Access Compliance Report

Public Rights-of-Way (Curb Ramps)

Intersection ID: 17513	Main Street: PROVIDENCE_DR	Cross Street: PROVIDENCE_RD	Location: SW
ADA ID: DEA893E4B565	Ramp Type: Perp	Initial Pass/Fail: Fail	Overall Compliance: No
		Severity Score: 37.5

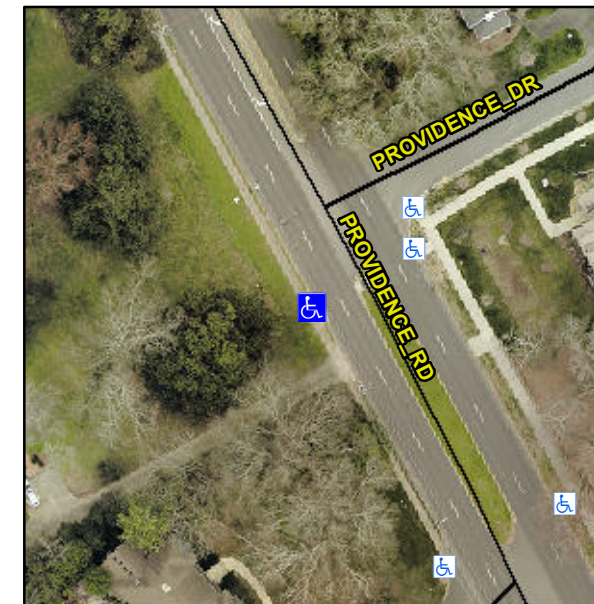
Not Found, R304.2.2, R304.5.3

Compliance	Description	Data	Compliance	Description	Data
N/A	Ramp Length (in)	24.0	No	Ramp Slope (%)	8.9
Yes	Ramp Width (in)	48.0	No	Ramp XSlope (%)	7.8
N/A	Flare Type LT	N/A	N/A	Flare Type RT	N/A
N/A	Flare Slope LT (%)	N/A	N/A	Flare Slope RT (%)	N/A
N/A	Flare Traversable LT?	N/A	N/A	Flare Traversable RT?	N/A
N/A	Landing Length (in)	N/A	N/A	DWS Provided?	N/A
N/A	Landing Width (in)	N/A	N/A	DWS Contrast?	N/A
N/A	Landing Slope (%)	N/A	N/A	DWS Length (in)	N/A
N/A	Landing X Slope (%)	N/A	N/A	DWS Full Width?	N/A
N/A	Landing Curb? (Y/N)	N/A	N/A	DWS Offset (in)	N/A
N/A	Shared Landing?	N/A			
N/A	Gutter Ponding?	N/A	N/A	Gutter Slope (%)	N/A
N/A	Gutter Lip Ht (in)	N/A	N/A	Gutter X Slope (%)	N/A
N/A	Painted X Walk1?	No	N/A	Painted X Walk2?	N/A
	X Walk 1 Direction	To NE		X Walk 2 Direction	N/A
N/A	X Walk 1 Width (in)	N/A	N/A	X Walk 2 Width (in)	N/A
	X Walk 1 Slope (%)	3.2		X Walk 2 Slope (%)	N/A
	X Walk 1 X Slope (%)	7.6		X Walk 2 X Slope (%)	N/A

Remove & Replace Entire Ramp.
